Staff Report

Item: DR 2020-05 & PLA 2020-03 “La Morenita Tortilla Bakery” at 2230 and 2400 N. Pacific Highway

Action on a land use application, Design Review DR 2020-05 and Property Line Adjustment PLA 2020-03, for the construction of a new commercial tortilla bakery facility.

Figure 3.01B – Major Arterial

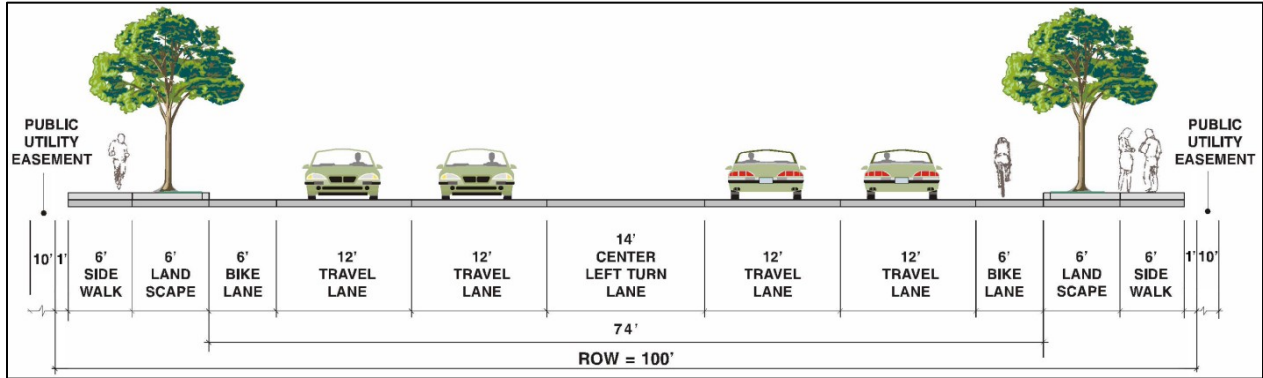
The site abuts N. Pacific Highway, a public street. Transportation System Plan (TSP) Figure 2 classifies N. Pacific Highway as a Major Arterial street, for which the corresponding WDO cross-section is Figure 3.01B.

Existing conditions of N. Pacific Highway along the site's frontage include a variable ROW width that appears to be between 87 and 95 feet, four travel lanes, a center turn lane, a bike lane, curb and drainage facilities, and a curbside sidewalk (no landscape strip). Additionally, City records do not indicate the existence of a public utility easement (PUE) along the frontage.

Staff applies *Condition of Approval DR-2* to dedicate ROW to achieve 50 ft from centerline, dedicate a 10-ft PUE along widened ROW, remove existing curbside sidewalk, and construct new 6-ft landscape strip with street trees and 6-ft sidewalk.

- a. Per WDO 3.01.01A. and Figure 3.01B, dedicate right-of-way (ROW) along N. Pacific Highway to achieve 50 feet from centerline.
- b. Per WDO Figure 3.01B and 3.02.01C., dedicate a 10-foot public utility easement (PUE) along the widened ROW of N. Pacific Highway.
- c. Per WDO Figure 3.01B, remove the existing curbside sidewalk and construct a new 6-foot landscape strip (including curb) and 6-foot sidewalk, which shall transition to existing sidewalk along adjacent property frontages in a manner acceptable to the City Engineer.
- d. Per WDO Figure 3.01B and 3.06.06A, plant four large street trees (large tree per Table 3.06B and of a species not listed in Table 3.06C) within the new landscape strip.
- e. Subsections a. and b. are due prior to building permit issuance, subsections c. and d. are due prior to building permit final inspection.

Excerpt of TSP Figure 6

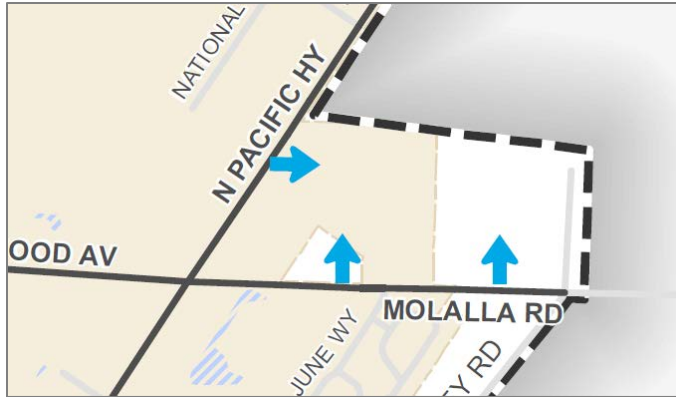
As can be seen in TSP Figure 6, a blue arrow pointing eastward appears to cover the subject properties. Considering this blue arrow in terms of regional connectivity, the City has clearly indicated its intention to construct several Local streets in the area northeast of the N. Pacific Highway / Mt Hood Avenue / Molalla Road intersection. Figure 6 is not intended as a construction document that illustrates an exact location of a future Local street. Rather, as development or redevelopment of properties in this area occur, staff is obligated to consider these identified Local street connections and how they would fit in with the proposed development. WDO Figure 3.01G is the default cross-section for local streets.

Based on these facts, staff considered the subject properties and neighboring properties to determine the most feasible path for the future east/west Local street. Siting the street along the north property boundary of the resulting subject property (after lot consolidation) was the most logical solution because such an alignment could be continued straight east across the neighboring properties and could connect with the additional northward future Local streets coming from Molalla Road.

The property owner of this proposal would therefore be responsible for a “half-street” portion of the land needed for the future Local street, which is 30 feet plus a 5-foot PUE. As the future Local street is not yet a planned Capital Improvement Project, staff directed the applicant to dedicate a 35-foot PUE along the north property line of the consolidated lot to ensure the land remains free of structures and buildings, but could still be used by the property owner in the meantime.

Staff addresses this topic here in detail because a significant portion of the applicant’s narrative argues against the 35-ft PUE. Staff adds *Condition of Approval DR-3b* to confirm this PUE is required.

- a. Per WDO 3.02.01A., dedicate a 16-foot PUE centered along the looped 6-inch public water line.
- b. Per WDO 3.01.01C., 3.01.04A., 3.02.01C., and Transportation System Plan (TSP) Figure 6, dedicate a 35-foot PUE along the north property line of the resulting consolidated lot.
- c. Per WDO 3.04.03C.2., dedicate a 20-foot shared access easement benefitting 2200 N. Pacific Highway (Tax Lots 051W08A004700 and 4800).
- d. Subsections a., b., and c. are due prior to building permit issuance.

Figure 3.05C - Parking Space Striping

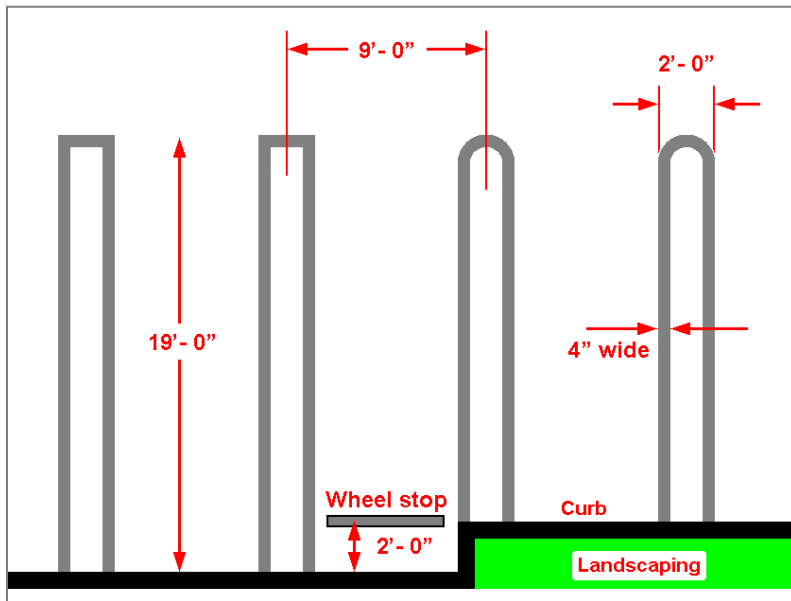
The plans show generally what these provisions require, except no directional markings or signs are illustrated per 3.05.02J. and stalls are not illustrated to be delineated by double parallel lines per 3.05.02K. and Figure 3.05C. Staff therefore adds *Conditions of Approval DR-4a* and *DR-4b* to meet these provisions.

- a. Per WDO 3.05.02J., revise plans to illustrate painted directional markings on pavement or directional signage throughout the parking lot.
- b. Per WDO 3.05.02K. and Figure 3.05C, revise plans to illustrate parking stalls delineated by double parallel lines.
- c. Per WDO 3.05.03B. and Table 3.05B, revise plans to note which accessible stall is the "Van Accessible" stall.
- d. Subsections a., b., and c. are due prior to building permit issuance.

LANDSCAPE PLAN

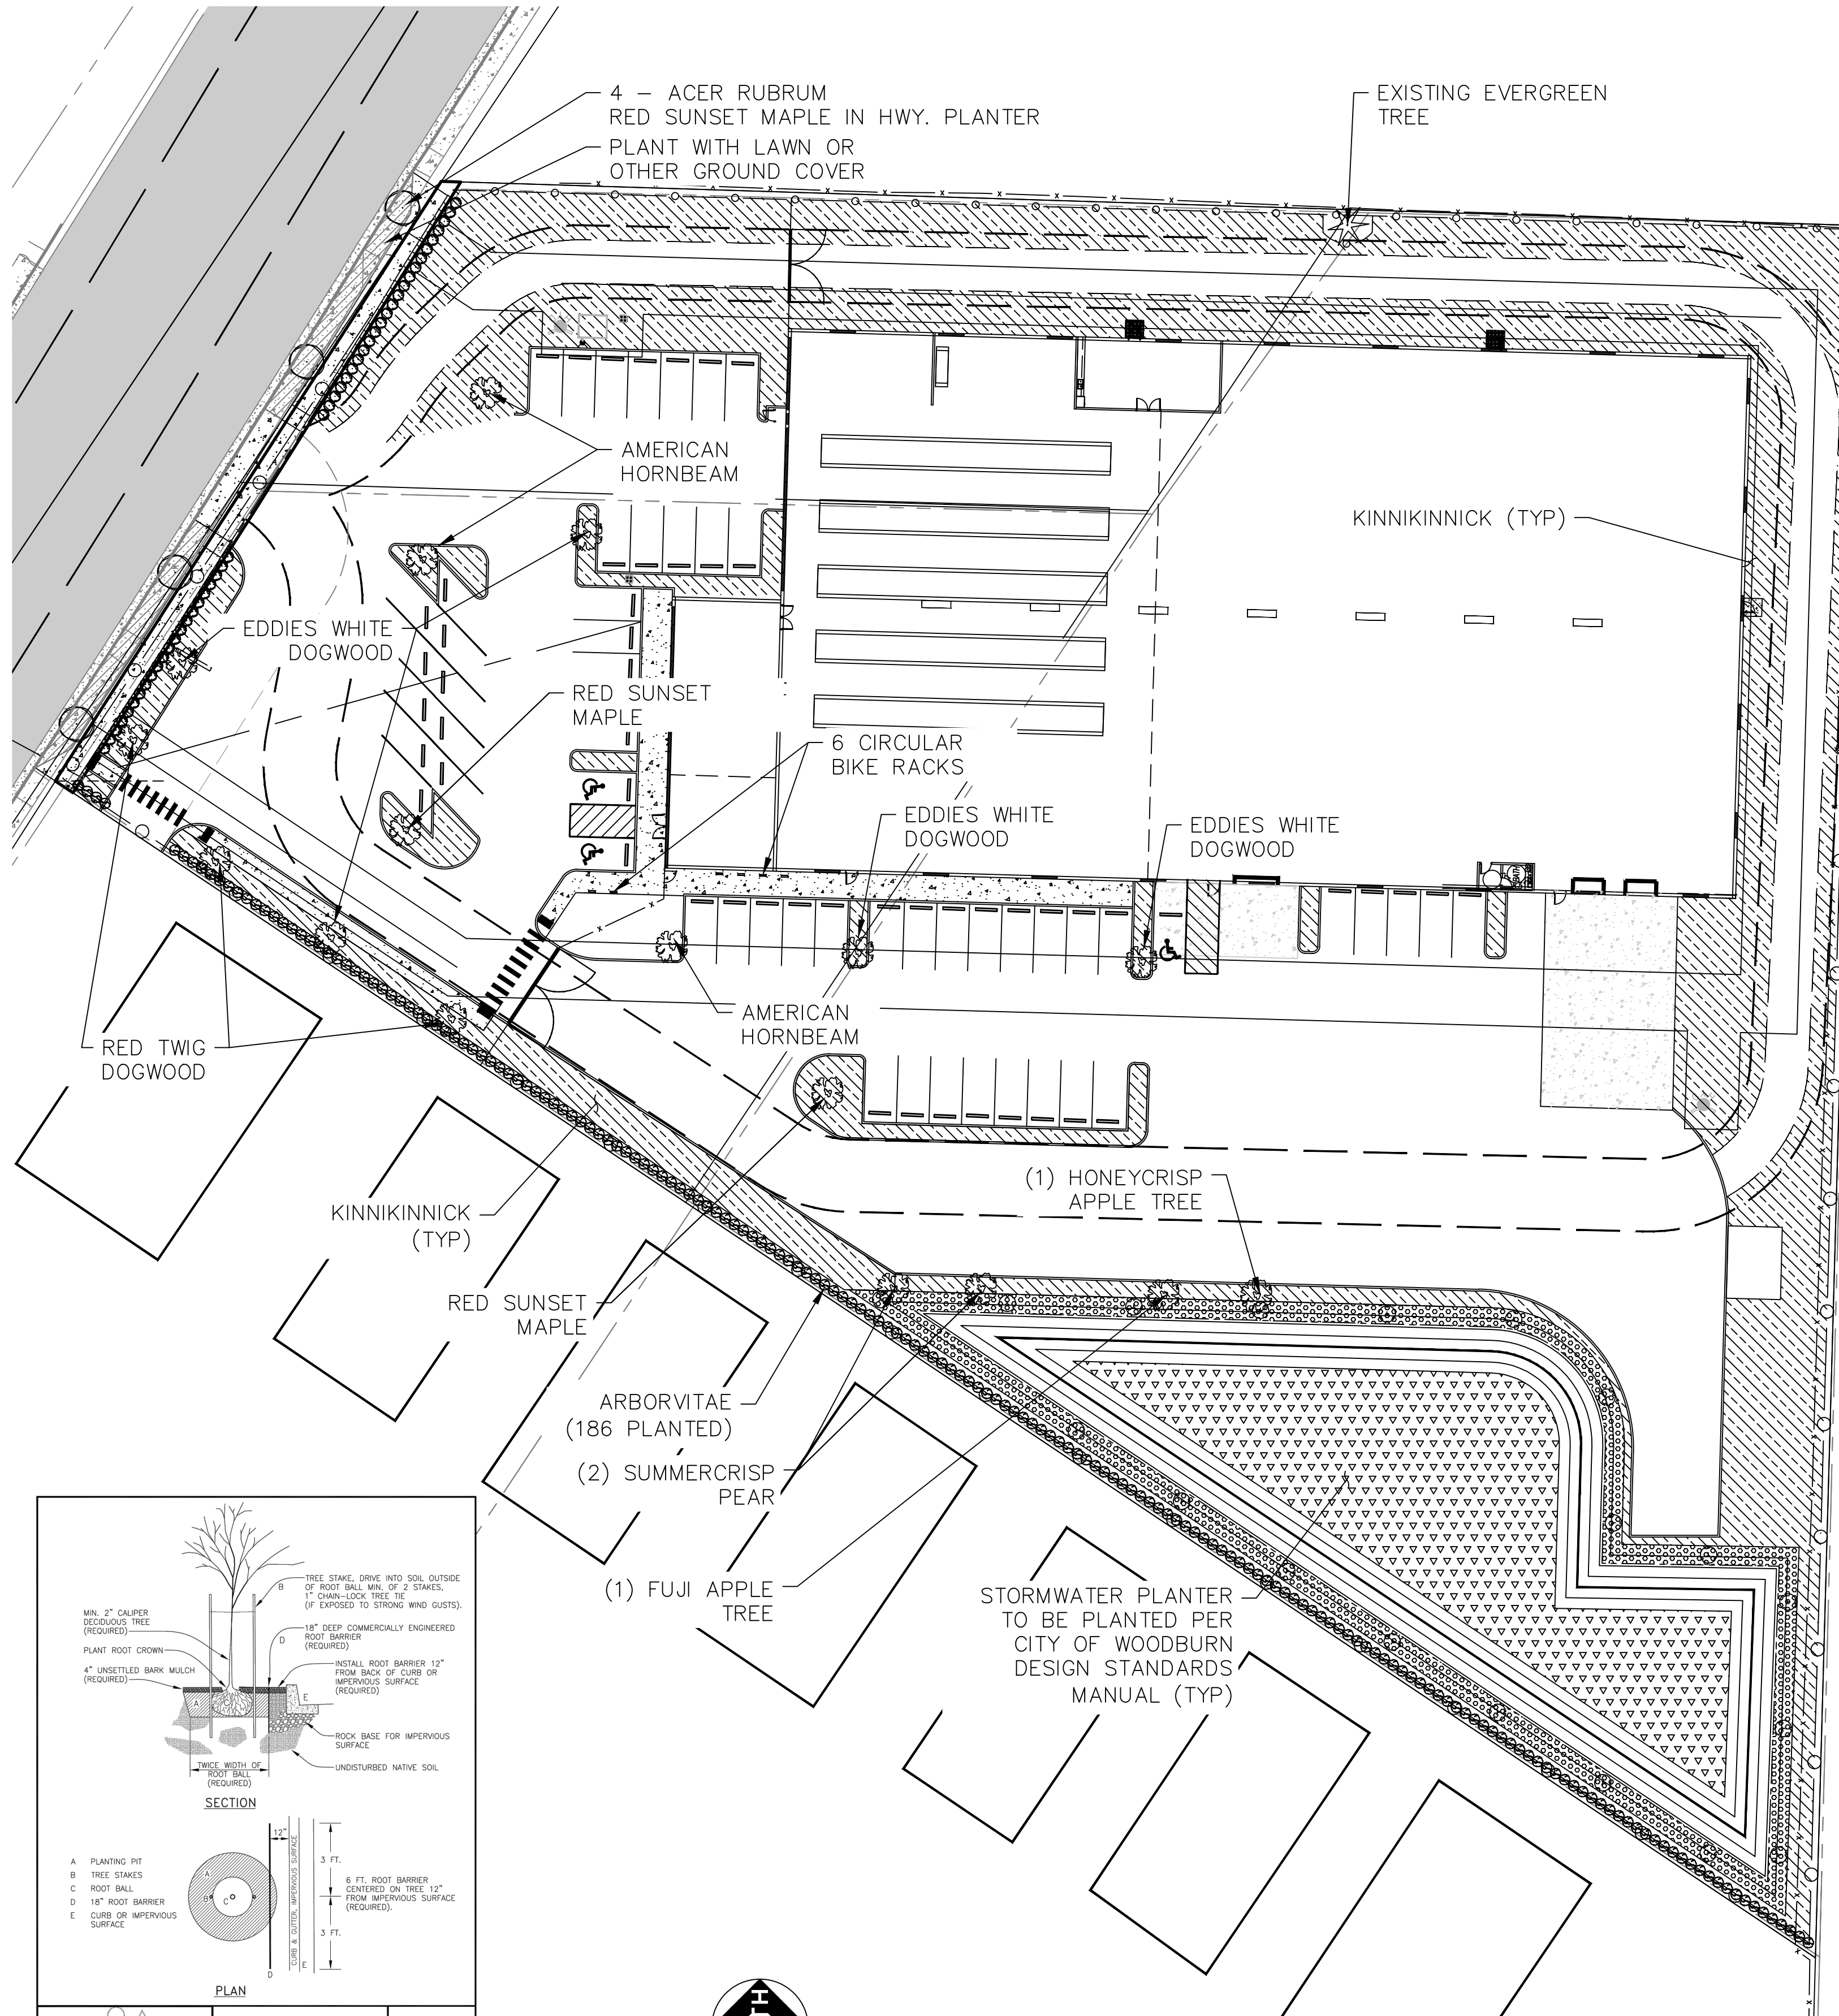
The landscape plans illustrate the general provisions are met, except the curbing requirement per 3.06.02I. Staff adds *Condition of Approval DR-5* to address this requirement.

The landscape plan illustrates 4 large street trees along the 200 ft of frontage. The plan also notes a landscaping requirement of 849 Plant Units (PUs) and 1,900 PUs provided.

DR-5. Landscape area curbing: Per WDO 3.06.02I., revise plans to note a 6-inch curb between landscape areas and on-site pavement. This condition is due prior to building permit issuance.

LA_MORENITA_TORTILLAS_INC.
WOODBURN, OR
BUILDING_ELEVATIONS

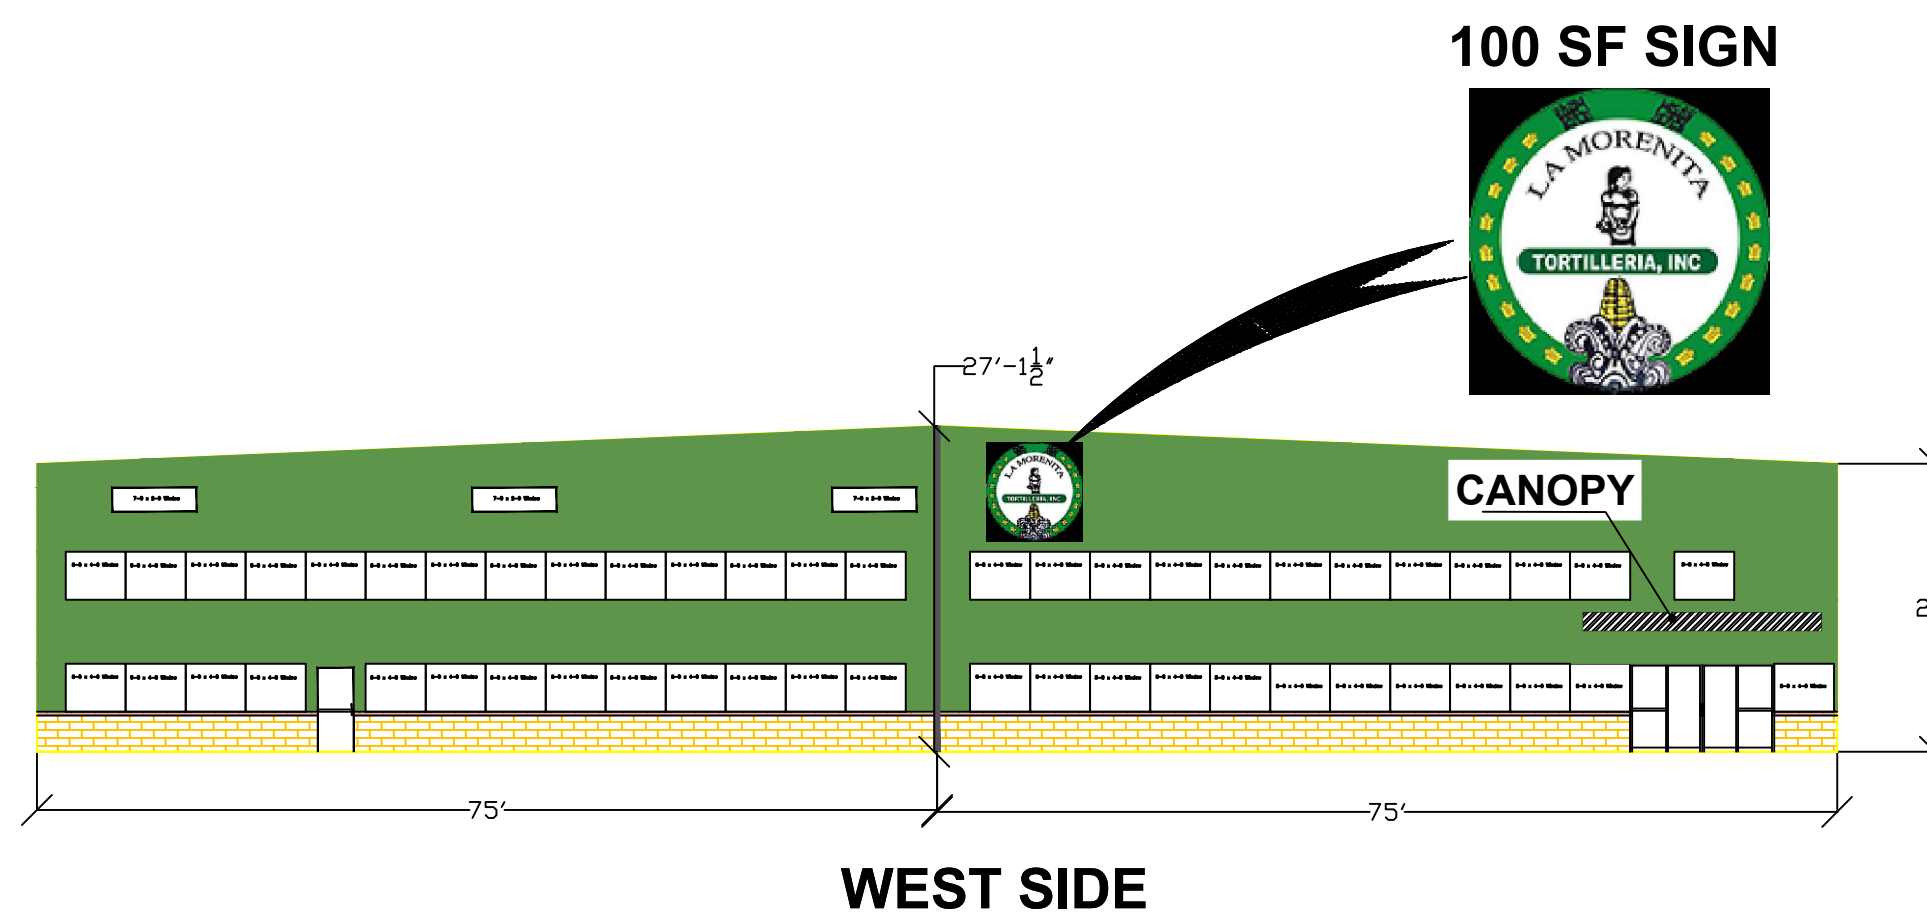
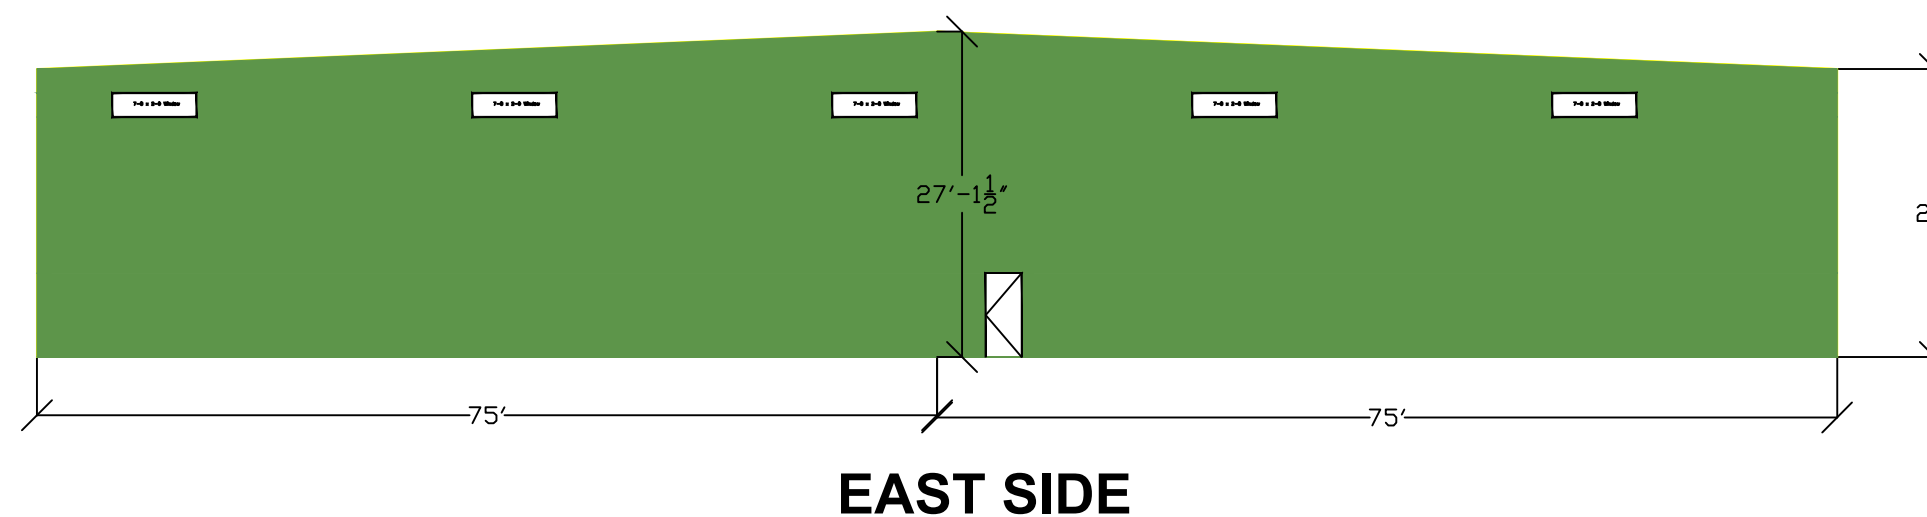
- a. Windows: Per 3.07.06B.2.b.(1), the west building façade shall have at least 30 percent of its area occupied by windows.
- b. Rooftop equipment: Per 3.07.06B.4., any rooftop equipment shall be screened from view from the street.

Notably, the applicant’s Incompleteness Letter Response received on August 12 outlines an argument regarding the window requirement of 3.07.06B.2.b.(1). The applicant argues that the proposed building does not directly abut the N. Pacific Highway ROW therefore this standard should not apply. Staff responds by considering the required setback abutting a street in the CG zone, a 5-ft minimum per Table 2.03C. This site development standard does not allow any building to abut a ROW therefore the Community Development Director has interpreted the intent of 3.07.06B.2.b.(1) to refer to building facades facing and visible from a street. Further, the proposal is construction of a new building and there is no reason the provision cannot be met. To that end, staff adds *Condition of Approval DR-7a* to confirm the 30 percent window coverage provision applies to the proposal.
